Urban Design Review Panel Report

New Campus Development for
The Ottawa Hospital
Phase 4: Main Hospital Project
Ottawa, Ontario

March 23, 2026
(Issued for SPC Resubmission)
Prepared by bbb Architects Ottawa Inc.

Figure 2.1-1: A0-221 PARKING LOTS ZONES 2A & ZONE 2B ZONE 4 ZONE 5B with dimensions at Main Drop-off Area

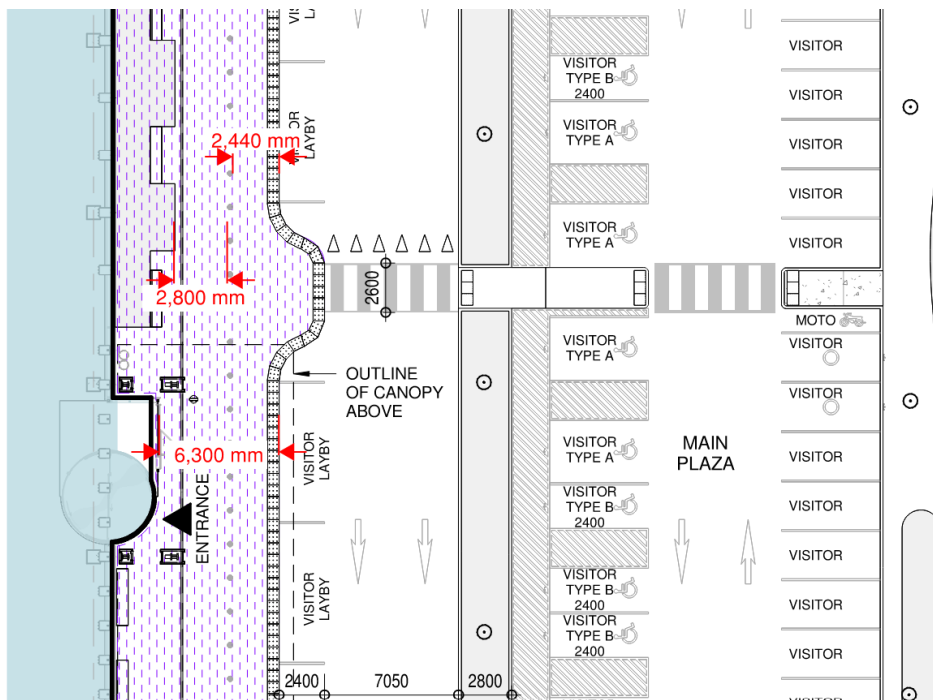
- The Panel expressed continued concern regarding the amount of space allocated to the main drop-off area.
 - The current pedestrian drop-off and pick-up zone, which is between 3.5 and 5 meters wide, remains on the narrower side given the level of activity expected in this area. The Panel recommends increasing the minimum width to 5 meters to better accommodate pedestrian movement and congregation.

The main drop-off area includes 6 layby parking spaces with adjacent access aisles that are a minimum of 2.44m wide. There is a sidewalk with a space of 2.8m from planter to bollards across the main pedestrian zone for a total width of 5.24m between parking spaces and planters. A distance of 6.3m is provided at the Main Entrance, refer to dimensions in Figure 2.1-1 below from A0-221.

Figure 3.1-1: Site analysis diagrams

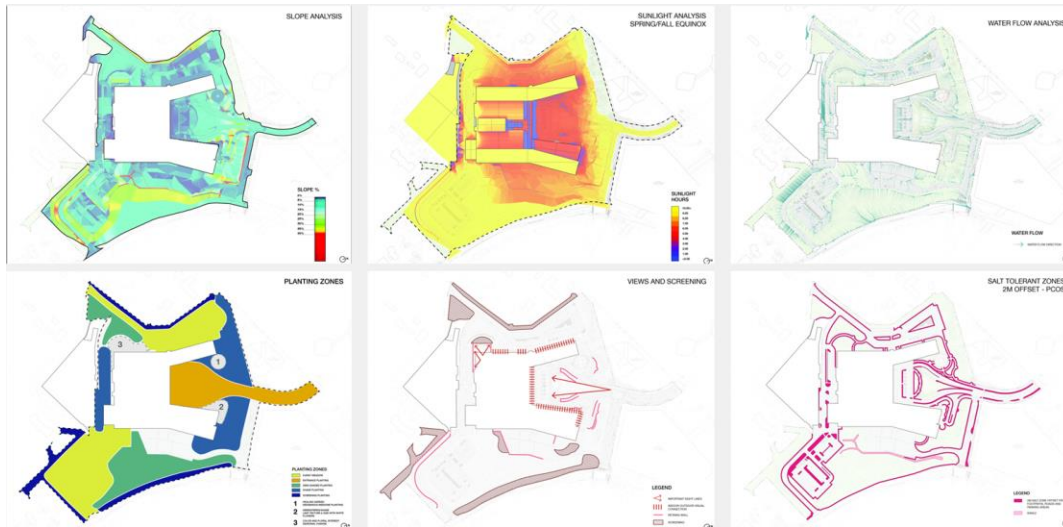
- The Panel recommends organizing the landscape into character areas to help rationalize the design moves and enhance the relationship between soft and hardscape elements, as well as improve connectivity throughout the site.

Site analysis was conducted to best understand the variety of environmental and visitor impacts. This site analysis informed the understory planting character of different zones across campus, including the entrance planting, sunny meadows, shaded woodland gardens and screening planting.

There are also four distinct gathering spaces on campus, each with distinct character defined by planting and topography, but with common materials and furnishings creating a cohesive campus identity. The Main Entry Plaza welcomes visitors to the hospital concourse, bringing a human scale to the plaza bordered by the towers and podium. The Overlook provides a space of respite for loved ones, or can act as an open, passive recreation space. Views to the Wooded Ridgeline and beyond to the City of Ottawa are enhanced by the framing grove of evergreen trees and the gentle slope of the landscape. The Dining Terrace offers space outside of the Pavilion for café seating and general gathering, set down from Road A providing some sense of intimacy and protection from the wind. The Healing Garden incorporates Indigenous design principles and medicinal plants, defined by a rustic dry-laid stone wall oriented to the cardinal direction points. Set within a birch forest, and further softened with native plantings as well as traditional medicinal plants, the space offers reflection and connection for visitors.
